October, 30, 2012

*RE: Mt Hope Project, Water Pollution Control Permit NEV2008106*

### **Basis for Critique of Monitoring Plan**

**Figure 1: Snapshot from WPCP application Figure II-9 showing proposed monitoring wells and groundwater contours. The yellow wells have already been constructed.**

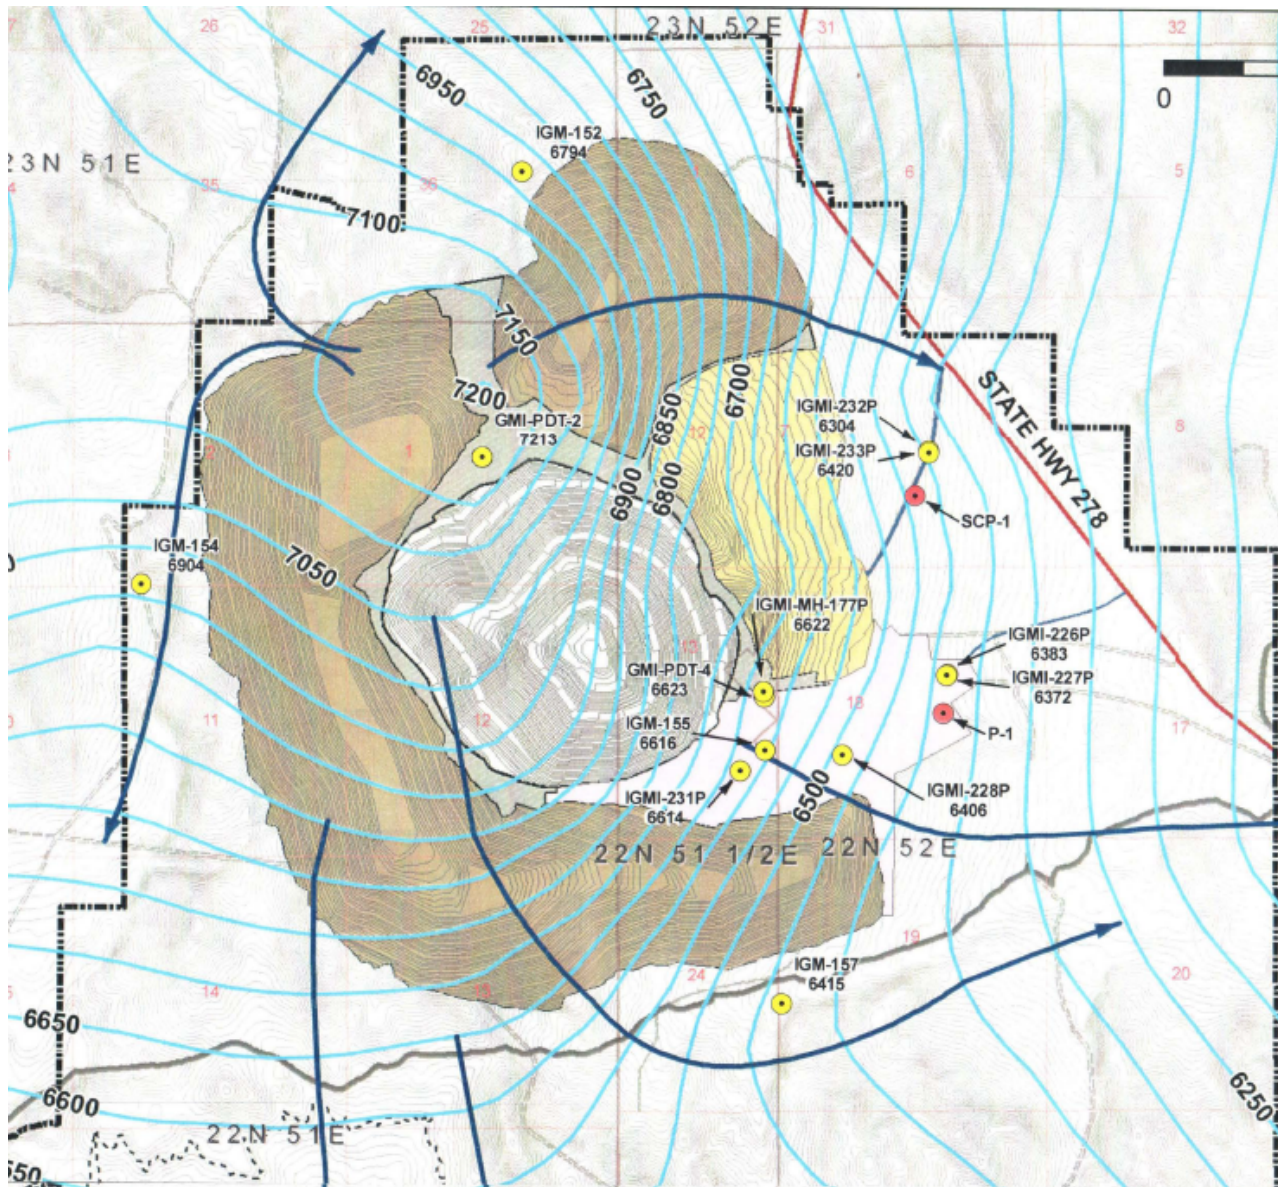
the valleys; Figure 1 shows that the crest of the groundwater divide is just north of the pit and that the flow direction under the PAG waste rock dump and the low-grade-ore stockpile (east of the pit) is to the east. The groundwater crest lies just northeast of the proposed tailings impoundment, so the flow across the tailings impoundment is to the southwest (Figure 2). The following consideration of the monitoring well locations relies on flow paths as described here.

The draft permit specifies the monitoring wells associated with different mine components (section I.D (10).) The non-PAG waste rock dump encircles the pit to the west and south (Figure 1). The draft permit states that well GMI-PDT-2 is upgradient of the facility; Figure 1 shows that that this well is existing and that a flow arrow through the well would be toward the pit, not under the waste rock dump. Well IGM-154 is considered downgradient but lies west of the dump and the flow path through

it both up- and downgradient would not go under the dump. Well IGM-157 is on the southeast corner of the dump at a point where a flowpath would extend under the dump. At best, well IGM-157 is the only one that based on its location is properly located to monitor flowpaths that could actually transport contaminants from the waste rock dump. Even if IGM-154 is on a proper flowpath (it is not), it is separated from IGM-157 by several miles; a huge contaminant plume could advect south and southeast from the waste rock between the monitoring wells without being detected. It is essential that at least three additional monitoring wells that screen across the water table be constructed along the southern boundary of the non-PAG waste rock dump west of IGM-157.

The LGO stockpile lies east of the pit. The draft permit specifies that monitoring well SCP-1, IGMI-232P, and IGMI-233P are downgradient monitoring wells. Figure 1 confirms that all three lie on flow paths which flow beneath the stockpile. However, the IGMI wells appear to be at the same point. Well logs show these are both deep wells screened far below the water table. IGMI 232-P is screened from 1018 to 998 feet below ground surface (bgs) in shale with static water level at 763 ft bgs while IGMI 233-P is screened from 568 to 548 feet bgs in tuft with static water level at 85 ft bgs. Neither report indicates where water was first encountered nor are there geophysical logs in the application with which to determine saturated levels. These wells are apparently monitoring fracture zones in the respective lithologies. There is no discussion of how the monitoring depth was chosen, but it is reasonable based on the fractures and the dip of the formations that monitoring at this depth is warranted. However, a couple of shallower wells that screen any water levels in the alluvium are necessary. Well SCP-1 should be constructed to span the water table if there is a phreatic aquifer in the area; the permit should specify these construction details.

Wells IGM-152, -226P, and -227P are all called downgradient monitoring wells for the PAG waste rock dump. The latter two are east of the southernmost end of the LGO stockpile and not downgradient of the PAG waste rock dump. IGM-152 is northwest of the PAG waste rock dump (Figure 1) and the groundwater contours show that a flowpath intersecting this well would not be underneath the PAG waste rock dump. The wells as shown on Figure 1 and specified in the draft permit will not monitor the PAG dump. Basically, this permit will allow the PAG waste rock to not be monitored. NDEP should specify at least three new monitoring wells east of the PAG waste rock dump with depth to screen chosen based on the presence of a water table aquifer and the presence of fracture flow zones at depth, as in the wells east of the LGO stockpile.

**Figure 2: Snapshot from WPCP application Figure II-9 showing proposed monitoring wells and groundwater contours near the tailings impoundment. The yellow wells have already been constructed.**

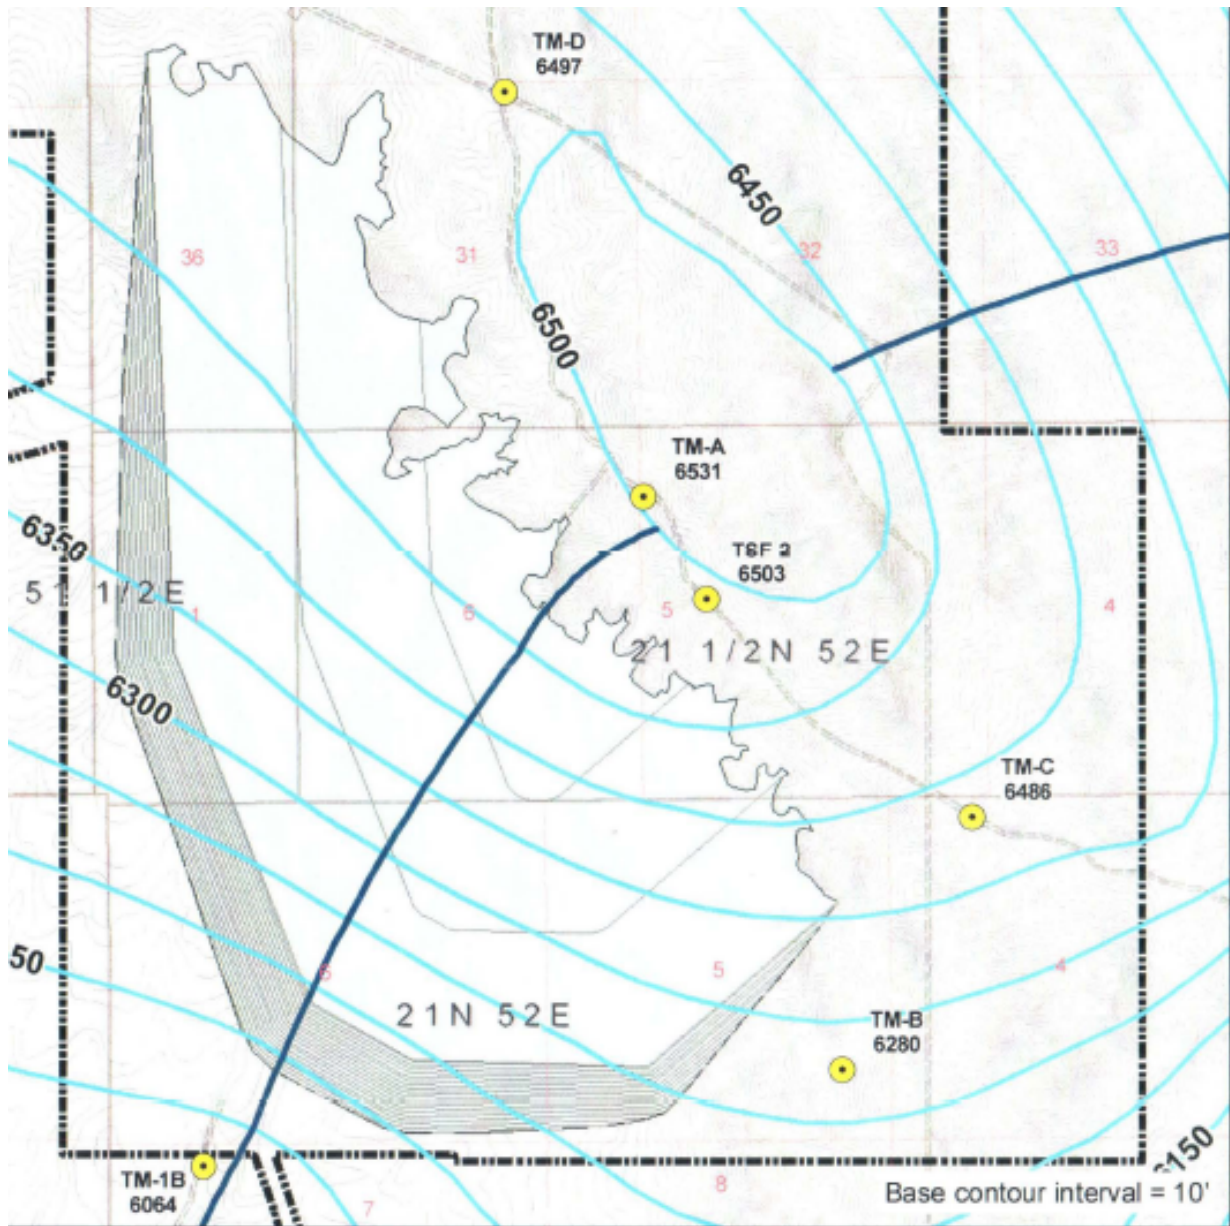
The tailings impoundment would be south of the pit. It lies southwest of the groundwater divide, therefore the groundwater flow will be to the southwest under the facility (Figure 2). The draft permit indicates that four upgradient and two downgradient wells will be used to monitor this site.

Figure 2 shows clearly that well TM-B is cross-gradient from the facility, although the draft permit refers to it as one of the two downgradient wells. A flowpath through this well would pass just east of the easternmost portion of the facility, therefore this well is not useful for monitoring contaminants

from the tailings impoundment. Wells TM-D, TM-A, and TSF-2 appear to be adequate upgradient monitoring wells, but well TM-C is also too far east; a flowpath through TM-C would miss the tailings impoundment by a quarter mile.

The draft permit therefore has just three adequate upgradient wells and one downgradient well. Because of the size of the impoundment and the potential contamination from leaky tailings, it is obvious there should be at least four additional monitoring wells downgradient from the tailings facility. Two should lie between TM-1B and TM-B and two should lie on a line between TM-1B and the number 6300 on the contour space about 1/3<sup>rd</sup> mile north from TM-1B.

Figure 3: Diversion channel and ponds near the proposed pit, from FEIS figure 2.1.5

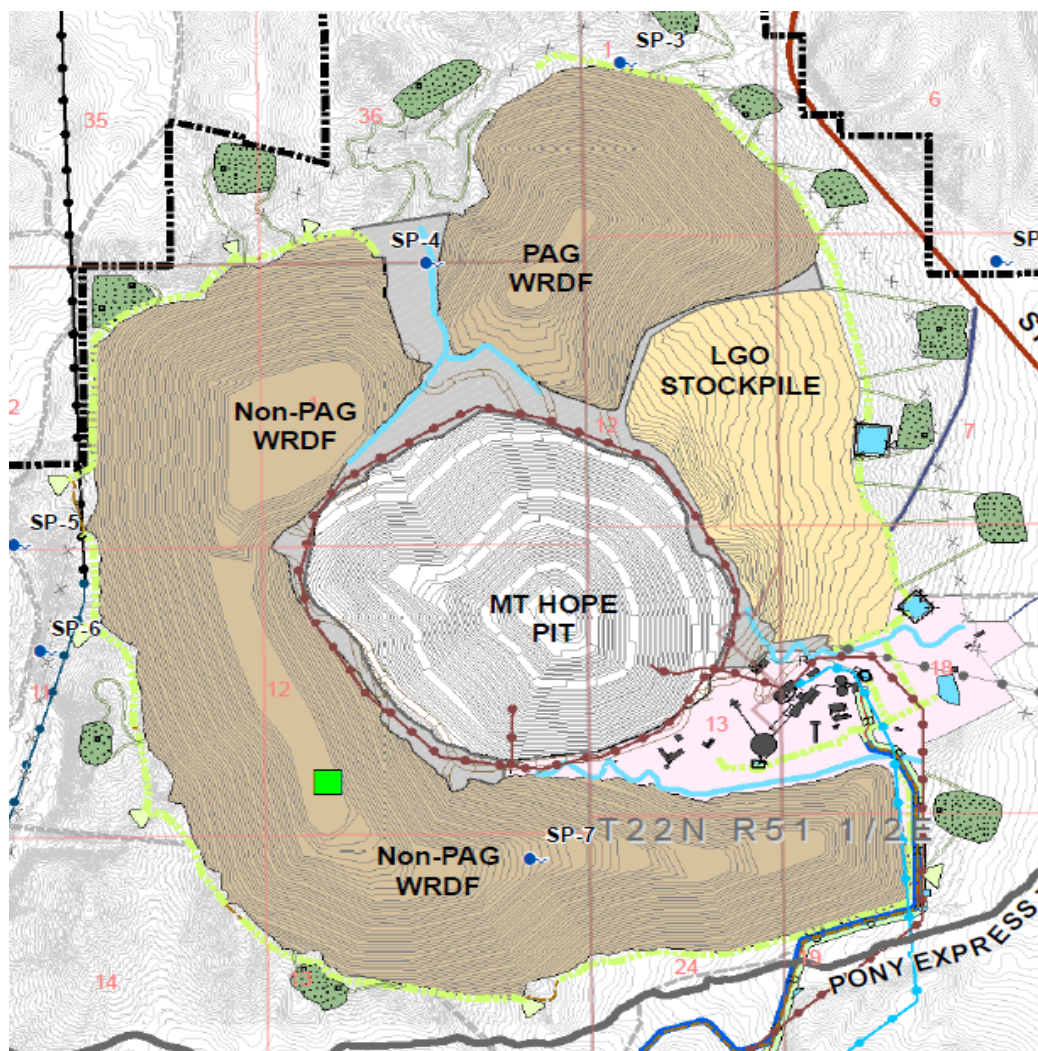
The diversion channels will pass adjacent to the west side of the PAG waste rock dump, as shown in Figure 3. The flow in the diversion channel will apparently contact the PAG rock in the PAG WRDF where it could seep and cause oxidation conditions along the southwest portion of the dump. NDEP should require that this channel be rerouted or a barrier installed to prevent a hydraulic connection between the channel and the PAG rock.
